Item Name: Crosstube Turning Detail

DRAWING NO. D206-667-243	TITLE CROSSTUBE ASS'Y (206L HIGH AFT)	REV. C	DART AEROSPACE LTD ENGINEERING ORDER		D.E.O. NO. D206-667-243-C-1	SHEET NO. - SHEET 1 OF 1	SCALE NTS
DRAWN <i>q</i>	CHECKED <i>ADS</i>	MFG. APPR. <i>RS</i>	APPROVED <i>MR</i>		DE APPR. <i>#</i>		
DATE 11.07.15	DATE 11.07.20	DATE 11.07.21	DATE 11/07/21		DATE 11.07.21

PURPOSE:

REPLACE MAGNOBOND WITH PROSEAL.

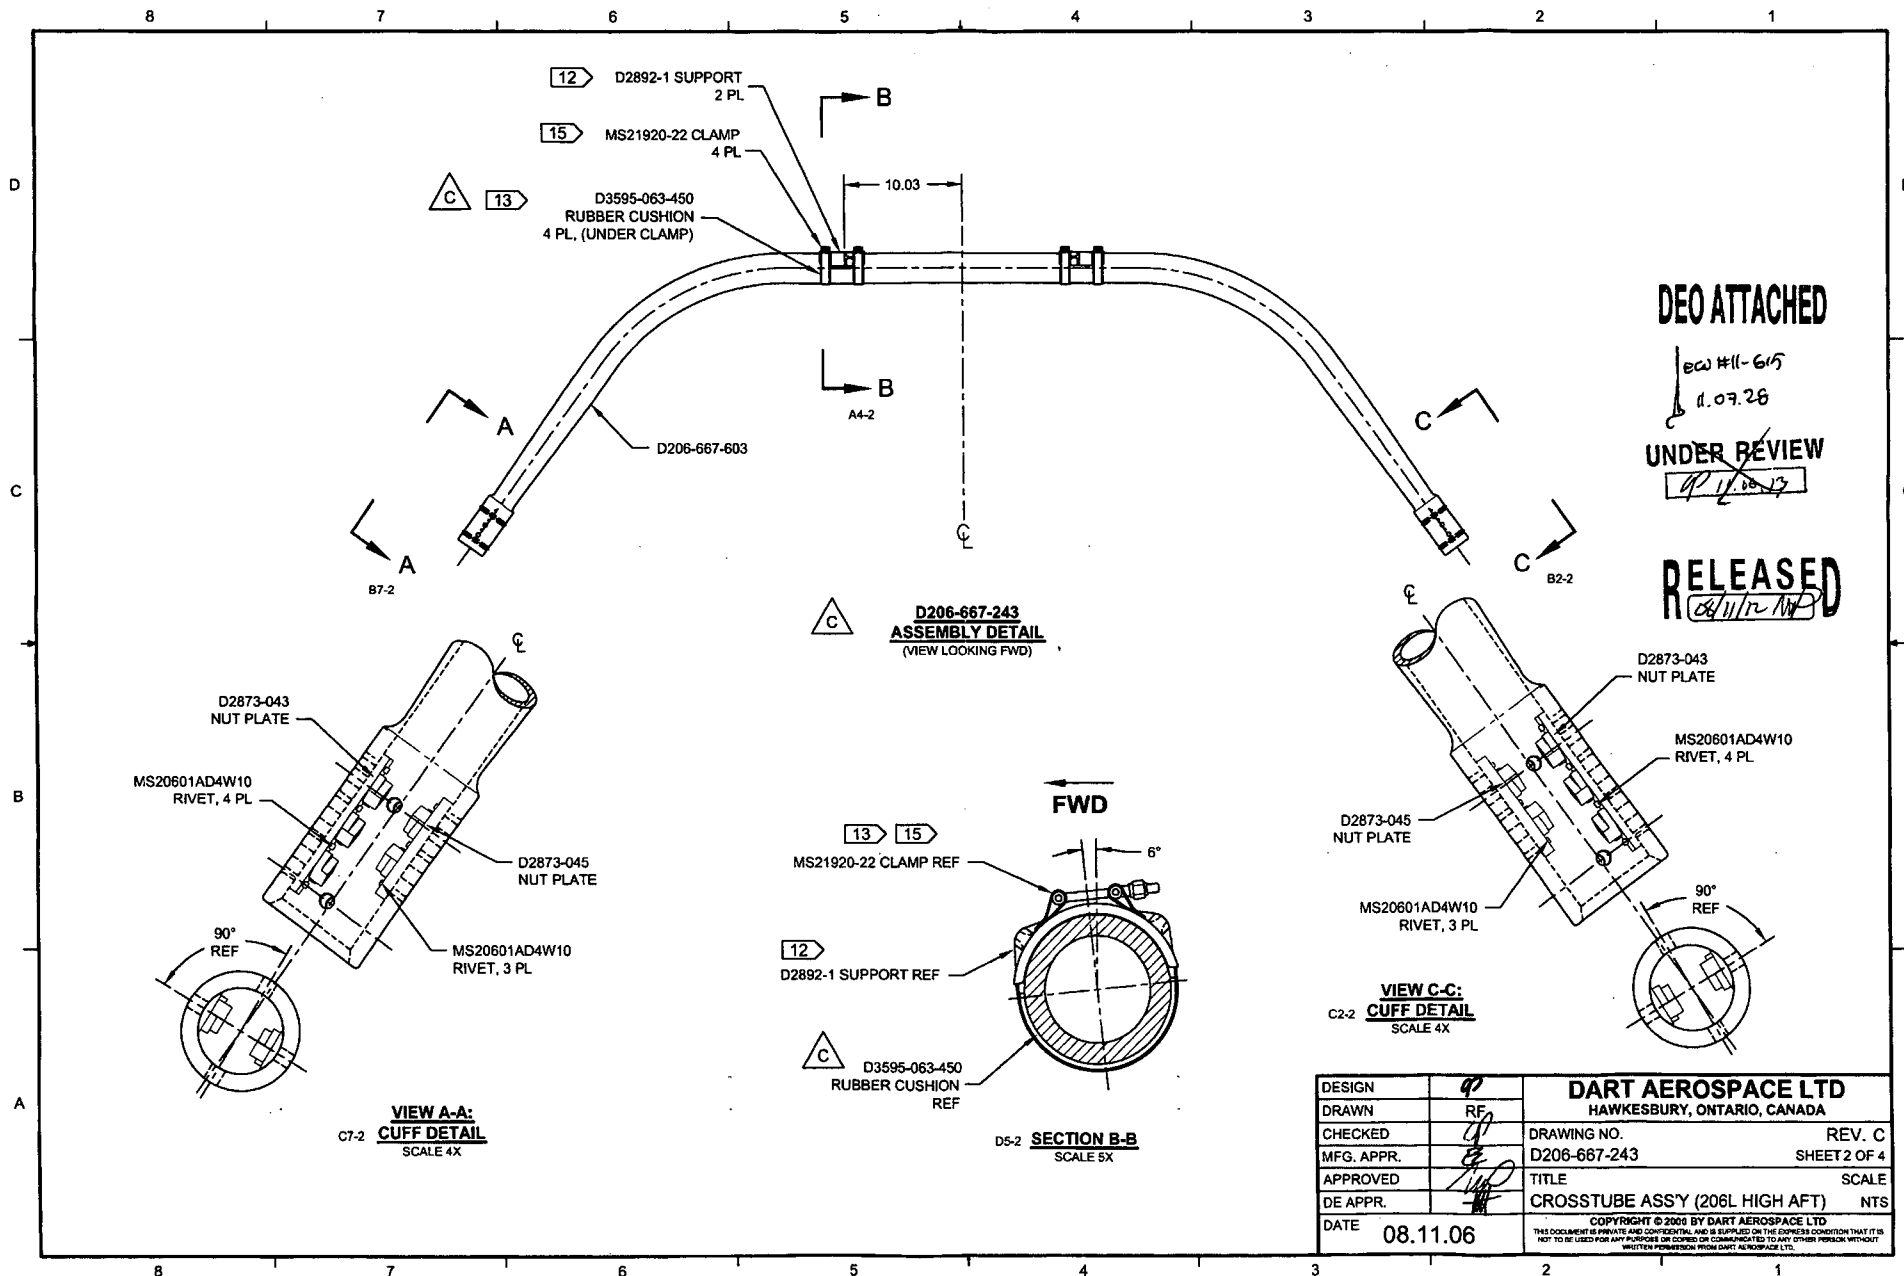
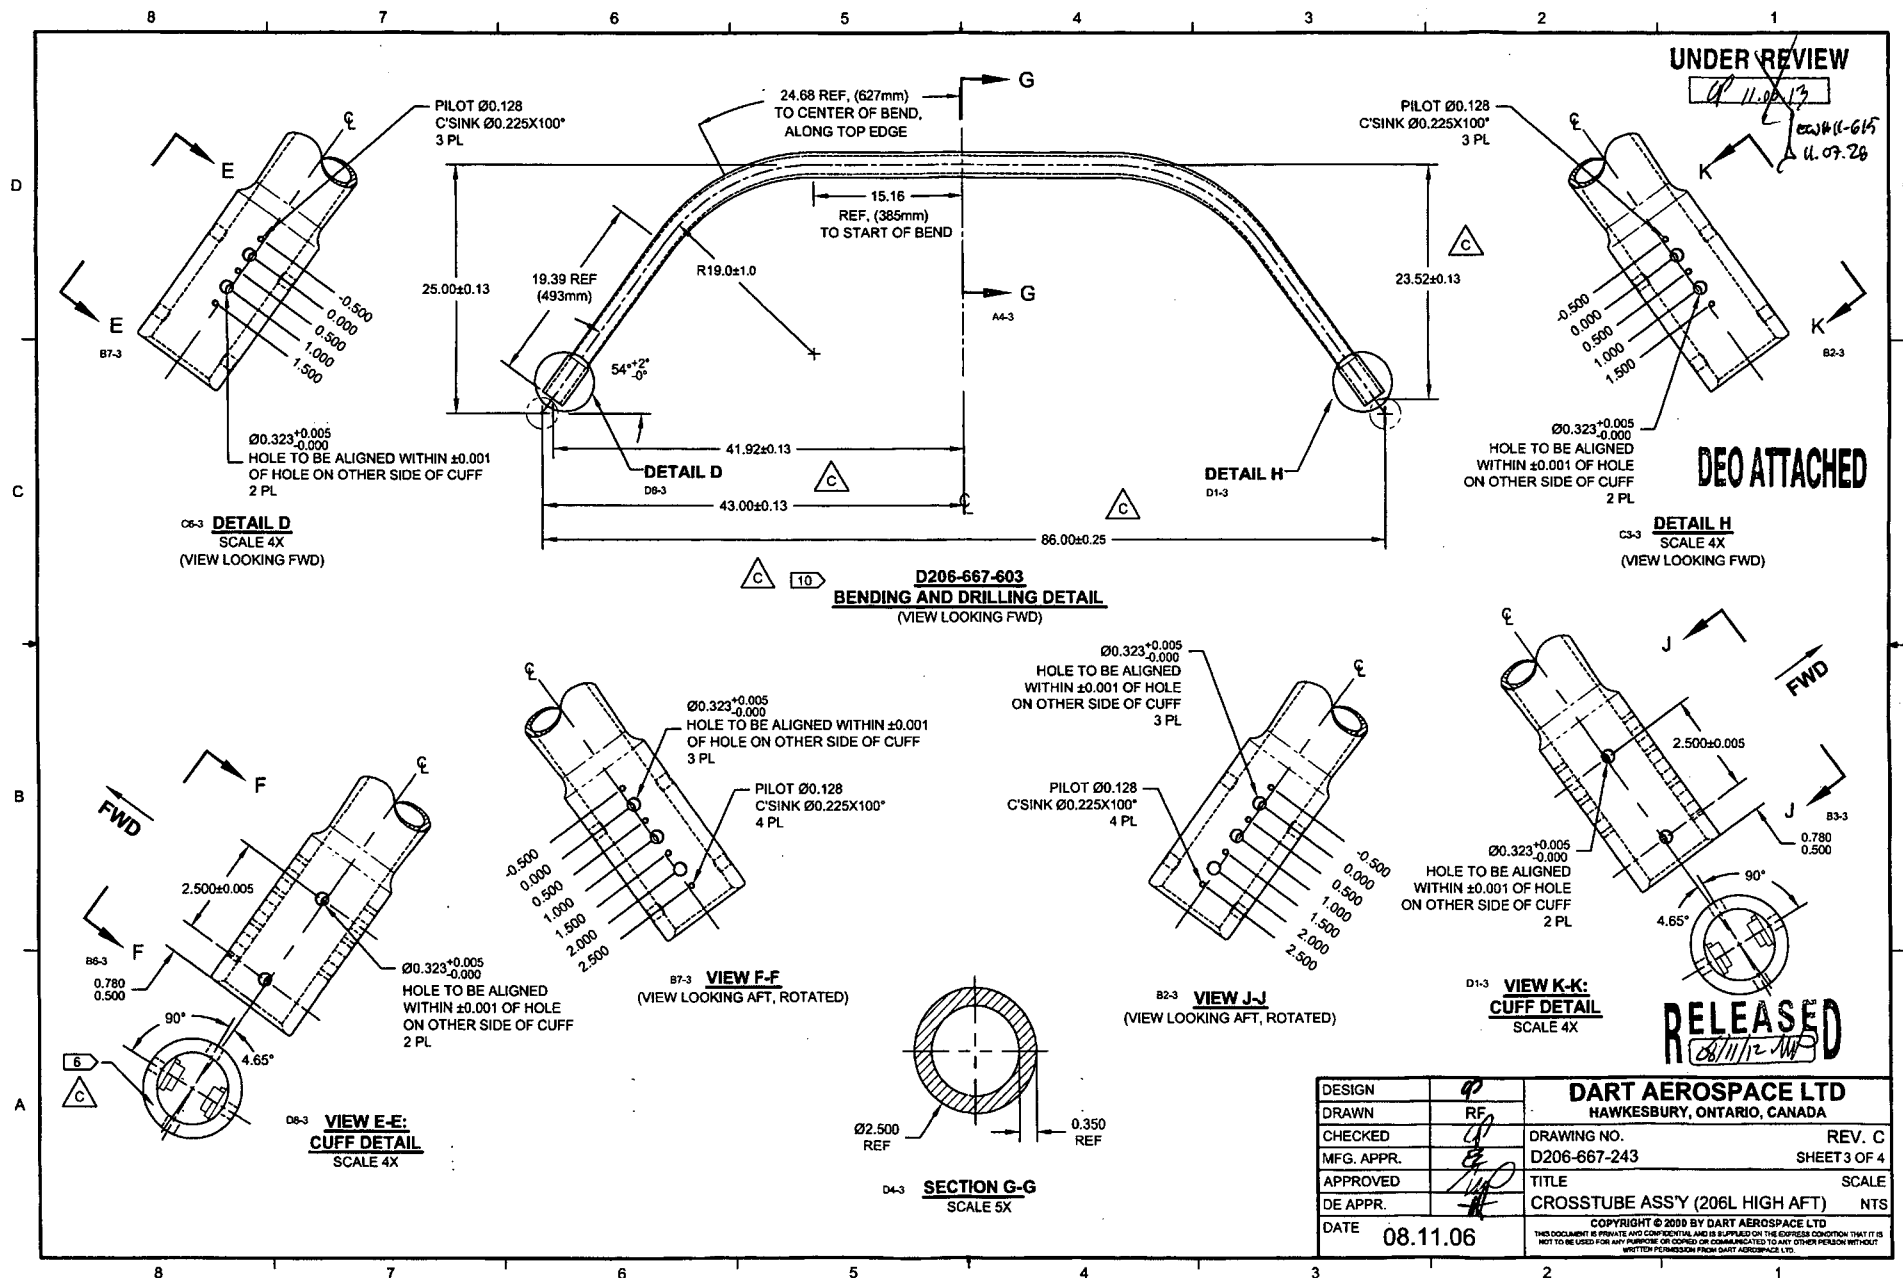
IS:

WAS:

9	A/R	MAGNOBOND 6398	ROCKWELL SPECIFICATION RBO-120-023 ADHESIVE (TEXTRON/BELL SPEC. 299-947-100, TYPE II, CLASS 2 ADHESIVE)
---	-----	----------------	---

NOTE 12 & 15, SHEET 1 IS AMENDED AS FOLLOWS:

WAS:

- 12) INSTALL D2892-1 SUPPORT USING 0.03" TO 0.06" THICK LAYER OF MAGNOBOND 6398 PER QSI 015. LET CURE FOR 12 HOURS AFTER INSTALLATION AND PRIOR TO PACKAGING.
- 15) TORQUE CLAMPS 80 TO 100 IN-LB. ENSURE AT LEAST 1.5 THREADS SHOWING IN SAFETY AND THAT NUT HAS NOT BOTTOMED-OUT AFTER TORQUING.

Item	Qty -243	Part Number	Description
9	A/R	PROSEAL 890 B-2	SEALANT, AMS-S-8802 CLASS B-2

IS:

- 12) TO INSTALL D2892-1 SUPPORT: ABRABE MATING SURFACE OF SUPPORT AND CROSSTUBE WITH 180-GRIT SANDPAPER AND REMOVE RESIDUE WITH MEK (OR EQUIVALENT). APPLY A 0.04" TO 0.07" THICK LAYER OF PROSEAL 890 CLASS B-2 (OR AMS-S-8802 CLASS B-2) SEALANT TO MATING SURFACE OF SUPPORT.
- 15) TORQUE CLAMPS 80 TO 100 IN-LB. ENSURE AT LEAST 1.5 THREADS SHOWING IN SAFETY AND THAT NUT HAS NOT BOTTOMED-OUT AFTER TORQUING. **PRIOR TO PACKAGING, RE-CHECK TORQUE ON CLAMPS AFTER PROSEAL 890 SEALANT HAS CURED FOR 72 HOURS.**
